NOTE ON IRRIGATION  
IN THE  
JHALAWAR STATE,

BY  
THE CONSULTING ENGINEER FOR IRRIGATION IN  
RAJPUTANA.

1903.

## NOTE ON IRRIGATION IN THE JHALAWAR STATE.

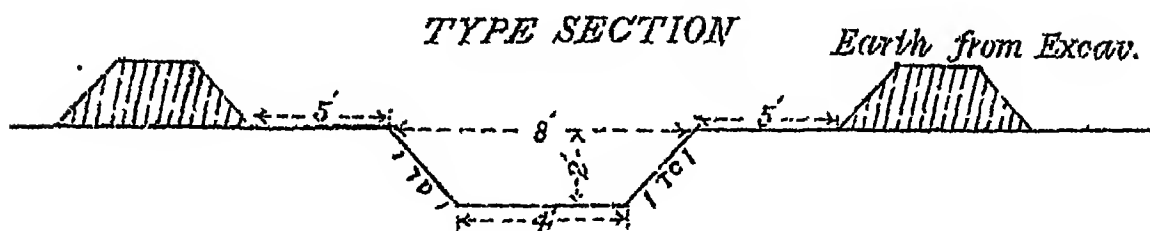
On the right bank 111 chains out of the 130 chains estimated for and set out have been partly excavated; and on the left bank 17 chains in extension of the 30 chains originally executed when the tank was constructed. In excavating the channels vertical sides have been given to save expense, and the earth excavated has been thrown up anyhow on either edge, even on sloping ground. This is a mistake, as in black soil the vertical sides will give way, and the earth on the edges is liable to fall in at any time. Except in rock and hard morrum, a slope of 1 to 1 should be given to the sides when constructing the channels, templates being constructed of the section of channel as a guide to the mates in charge.

On level ground, a berm of *at least* 5 ft. on either side should be given, and the earth excavated formed into a bank of proper section.

It will be found more economical to do this at once, will save any chance of sides and earth excavated falling back into the channel, and the channel can also be widened later if found necessary.

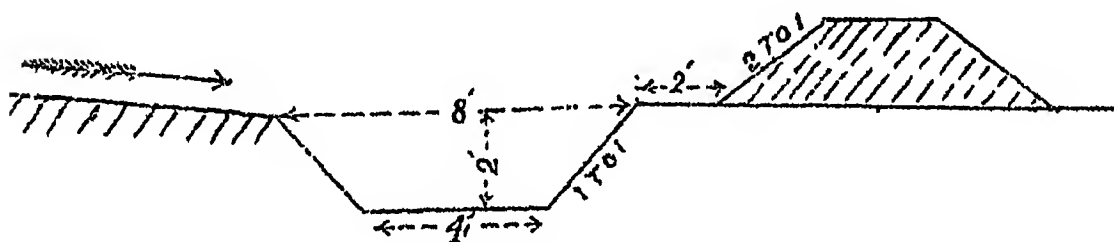
On side-long ground the earth excavated should be formed into a bank on the *lower side only*; and any surface drainage in the rains will then pass away down the channel.

The earth which has now been thrown up above the channel should be removed, otherwise in the rains it will all be washed back into the channel again, and cause trouble.

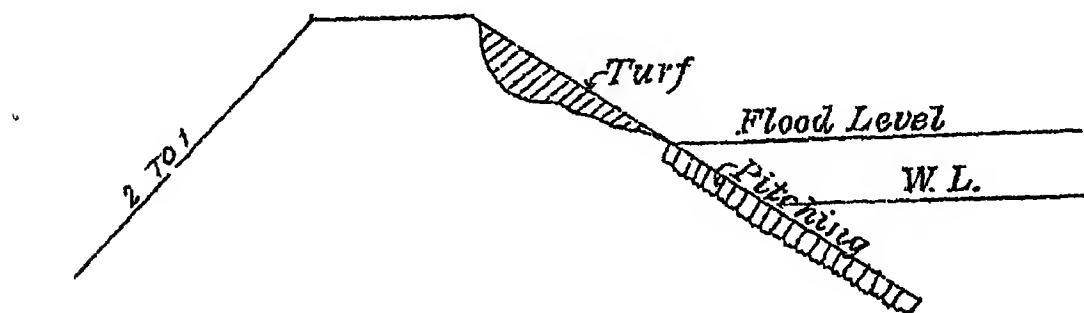
The dam would be extended on the north-west beyond the present weir till high ground is reached. At present the flood water damages the fields below at this end, and if the weir was altered I understand 25 bighas extra could be irrigated.

The front slope of dam, especially at south east end, wants making up, as it is cut up by waves, etc.; and it should be turfed down to flood level and pitched below, to prevent a recurrence of this.

Pitching is also required on the north-west side of sluice.

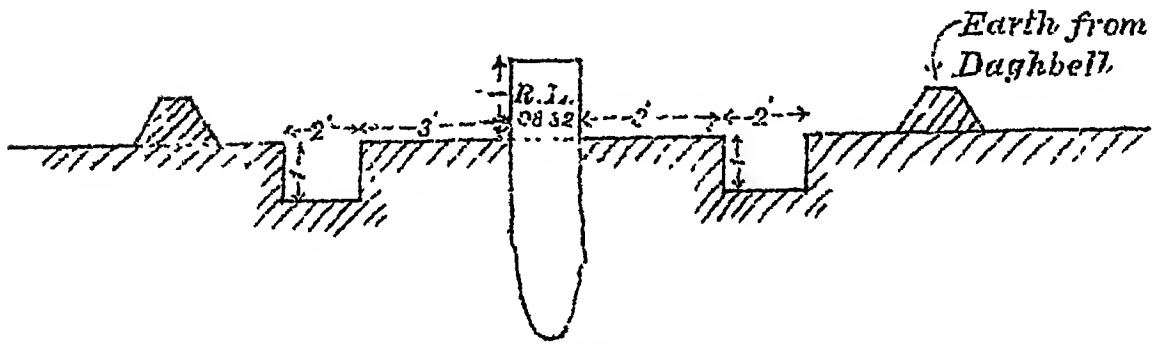
The dam is proposed to be 6 ft. wide at top, with front slope  $2\frac{1}{2}$  to 1 and rear slope 2 to 1. Crest 5 ft. above weir level. The front slope should be made 3 to 1. The size of Sluice and Irrigation Channel required is not given, these should be worked out always by—

- (a) Finding the discharge per second required to empty the tank in four months (Rabi Irrigation season);
- (b) And as water is required simultaneously at first for Irrigation, the discharge required per second to give a first watering of 6 inches in 30 days of 12 hour flow to the whole area for which there is sufficient water.

This has been explained in detail to the Assistant Engineer.

SECTION

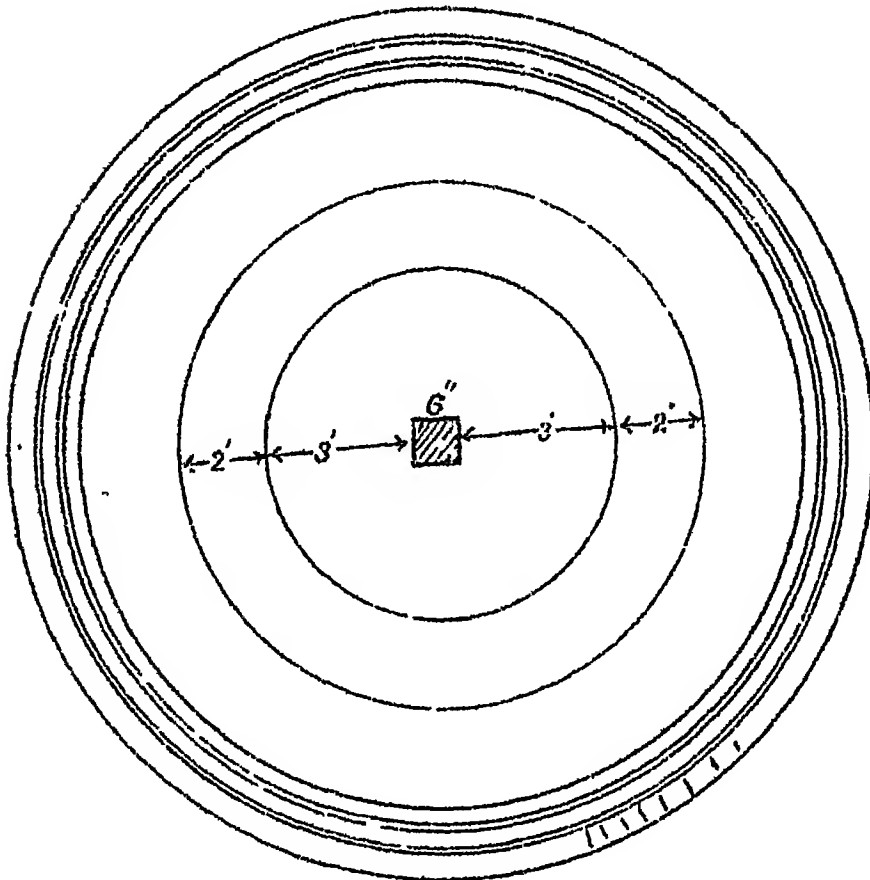
The line of the proposed dam was not daghbelled out, nor were there any permanent bench marks. Wherever

These bench marks should be stones set on edge, embedded  $1\frac{1}{2}$  in the ground, with a circular daghbell all round as per sketch, the number and reduced level, corresponding with Field Book, being marked on the stone.
